# Access Compliance Report

## Public Rights-of-Way

Intersection ID: 14914	Main Street: COOK_ST	Cross Street: CRESCENT_AV	Location: S
ADA ID: 936BB73DFD44	Ramp Type: Perp	Initial Pass/Fail: Fail	Overall Compliance: No
Severity Score: 37.5			
Codes/Mitigation Info/Possible Solution		Field Measurements/Component Compliance

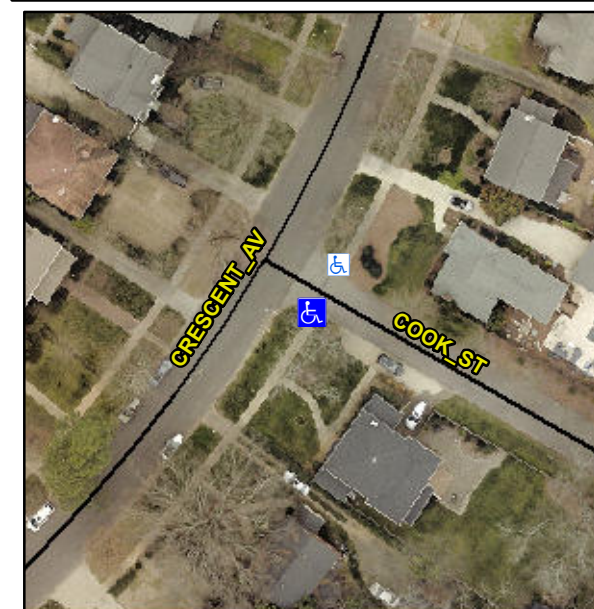
**R304.2.2, R304.5.3**

Compliance	Description	Data	Compliance	Description	Data
N/A	Ramp Length (in)	91.0	No	Ramp Slope (%)	10.6
Yes	Ramp Width (in)	59.0	No	Ramp XSlope (%)	7.3
N/A	Flare Type LT	N/A	N/A	Flare Type RT	N/A
N/A	Flare Slope LT (%)	N/A	N/A	Flare Slope RT (%)	N/A
N/A	Flare Traversable LT?	N/A	N/A	Flare Traversable RT?	N/A
N/A	Landing Length (in)	N/A	N/A	DWS Provided?	N/A
N/A	Landing Width (in)	N/A	N/A	DWS Contrast?	N/A
N/A	Landing Slope (%)	N/A	N/A	DWS Length (in)	N/A
N/A	Landing X Slope (%)	N/A	N/A	DWS Full Width?	N/A
N/A	Landing Curb? (Y/N)	N/A	N/A	DWS Offset (in)	N/A
N/A	Shared Landing?	N/A			
N/A	Gutter Ponding?	N/A	N/A	Gutter Slope (%)	N/A
N/A	Gutter Lip Ht (in)	N/A	N/A	Gutter X Slope (%)	N/A
N/A	Painted X Walk1?	No	N/A	Painted X Walk2?	N/A
	X Walk 1 Direction	To NE		X Walk 2 Direction	N/A
N/A	X Walk 1 Width (in)	N/A	N/A	X Walk 2 Width (in)	N/A
	X Walk 1 Slope (%)	3.8		X Walk 2 Slope (%)	N/A
	X Walk 1 X Slope (%)	2.6		X Walk 2 X Slope (%)	N/A

**Remove & Replace Entire Ramp.**
